UNITED STATES
DEPARTMENT OF THE INTERIOR
BUREAU OF LAND MANAGEMENTCarlsbad Field Office
OCD ArtesiaFORM APPROVED
OMB NO. 1004-0135
Expires: July 31, 2010**SUNDRY NOTICES AND REPORTS ON WELLS**
*Do not use this form for proposals to drill or to re-enter an abandoned well. Use form 3160-3 (APD) for such proposals.***SUBMIT IN TRIPLICATE - Other instructions on reverse side.**

1. Type of Well <input checked="" type="checkbox"/> Oil Well <input type="checkbox"/> Gas Well <input type="checkbox"/> Other		8. Well Name and No. SEVEN RIVERS 1742
2. Name of Operator OXY USA INC		9. API Well No. 30-015-41061
3a. Address PO BOX 4294 HOUSTON, TX 77210	3b. Phone No. (include area code) Ph: 713-840-3011	10. Field and Pool, or Exploratory N SEVEN RIVERS GLOR YESO
4. Location of Well (Footage, Sec., T., R., M., or Survey Description) Sec 17 T20S R25E 330FNL 2160FWL		11. County or Parish, and State EDDY COUNTY, TX

OXY USA INC respectfully request permission to change the location of the CTB that the production of the above mentioned well will be sent to. The permits showed that the CTB would be located on the Osage 18 Federal #1H well, but it will now be sent to the Seven Rivers 17 Federal #1 (30-

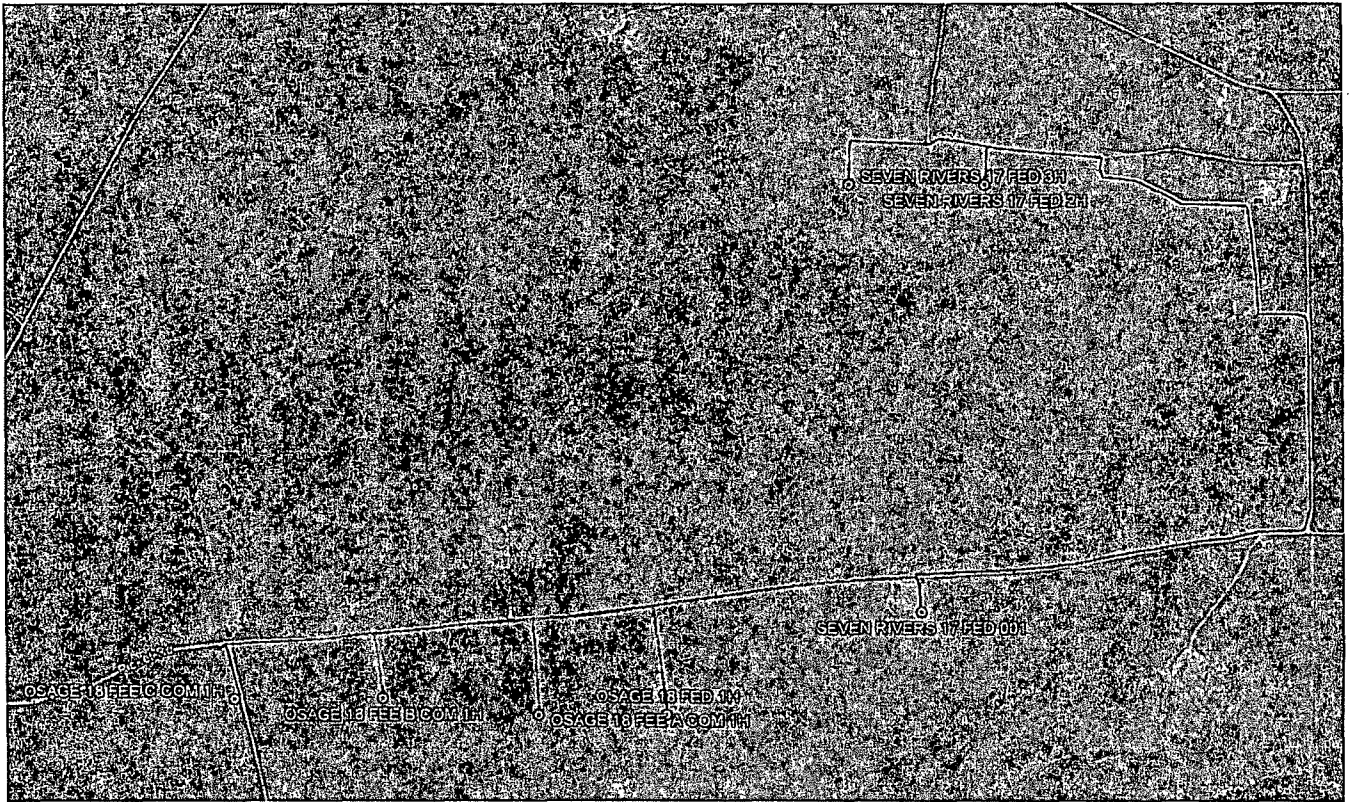
All production flowlines will be 4" SDR 7 Polyethylene flowline run on the surface at operating pressures less than 125 psig.

Ok, surface. Indradahal ref: 2014-532-CX approved 3/25/14
